RFQ NUMBER
DEP14158

LINE	QUANTITY	UOP	CAT NO	ITEM NUMBER	UNIT PRICE	AMOUNT
				<p>*****ADDENDUM NO. 1*****</p> <p>ADDENDUM ISSUED FOR THE BUFFALO COAL COMPANY PROJECT TO DISTRIBUTE THE PRE-BID SIGN-IN SHEETS, THE BID CLARI- FICATION, THE Q/A, AND SKETCH RESULTING FROM THE PRE- BID MEETING OF 12/17/2009.</p> <p>BID OPENING DATE AND TIME ARE EXTENDED TO 03/18/2010 AT 1:30 PM.</p> <p>*****NO OTHER CHANGES*****</p>		
0001	1	JB		962-73		
				<p>RECLAMATION: RESTORATION OF WATER</p>		
				<p>***** THIS IS THE END OF RFQ DEP14158 ***** TOTAL:</p>

**Addendum #1 - Questions During Pre-Bid Conference
For DEP 14158
Buffalo Coal Company, Inc. Permit # S-2003-88**

GRouted V - DITCH

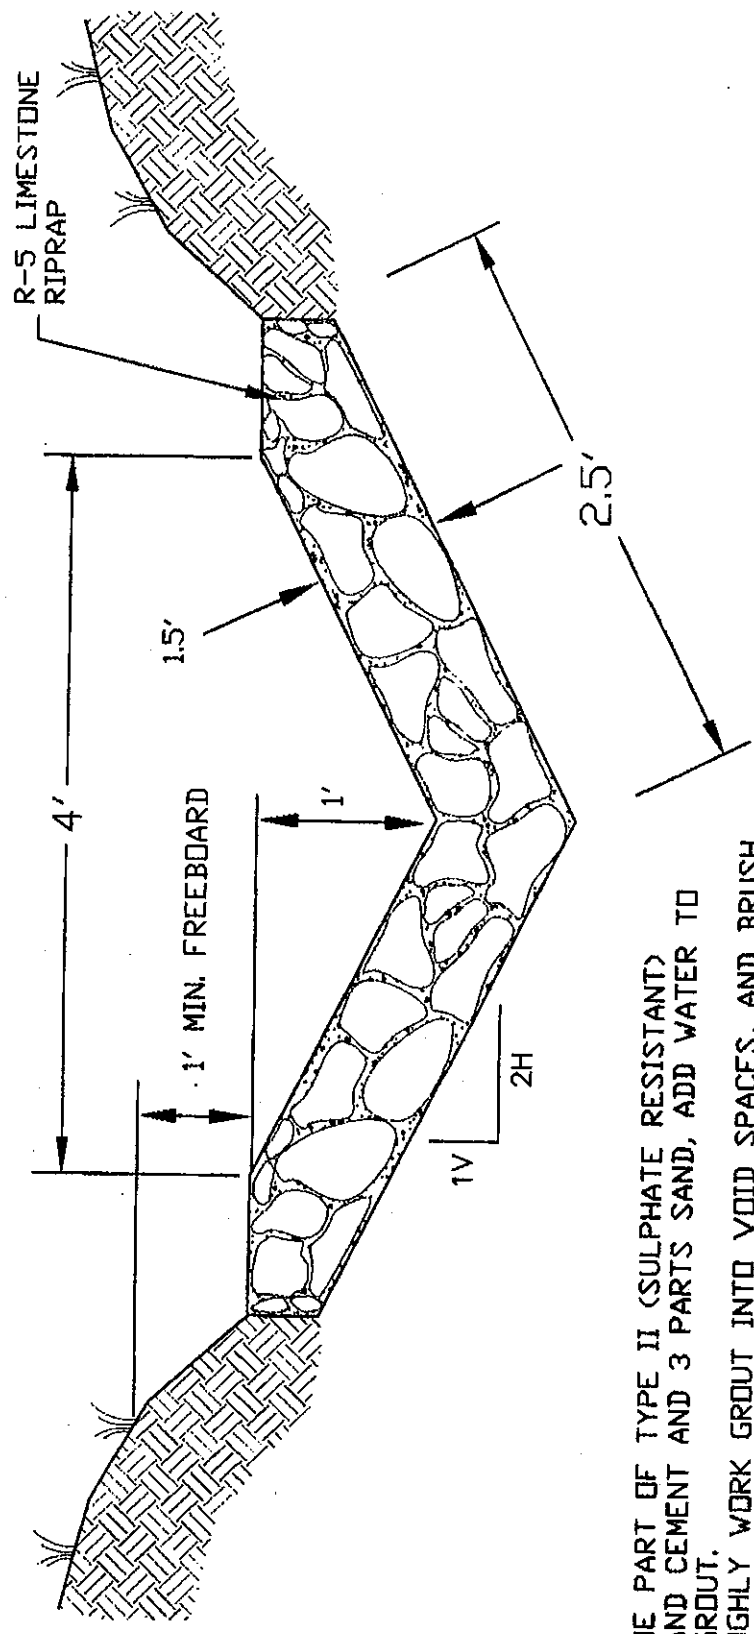
Clarification to Bid Item 8.0 Grouted Riprap Ditch-4': The thickness of the riprap shall be 1.5 feet and use R-5 classification limestone. A revised drawing is attached, which was on page 72 of the requisition.

R-5 LIMESTONE RIPRAP (STANDARD) UNLESS OTHERWISE NOTED, RIPRAP SHALL BE DURABLE ROCK PLACED IN A 1.5 FOOT BLANKET. TWENTY-FIVE (25%) OF THE ROCK WILL BE OF 18 INCHES OR LARGER, THE REMAINING SEVENTY-FIVE (75%) SHALL BE WELL GRADED MATERIAL (MINIMUM 3 INCHES TO MAXIMUM 15 INCHES) OF SUFFICIENT ROCK SMALL ENOUGH TO FILL THE VOIDS BETWEEN THE LARGER ROCK. SHALE SHALL NOT BE USED FOR RIPRAP. IF RIPRAP STABILITY IS QUESTIONABLE, DURABILITY SHALL BE DETERMINED BY THE SODIUM SULPHATE TEST ASTM C 88/AASHTO T 104-77.
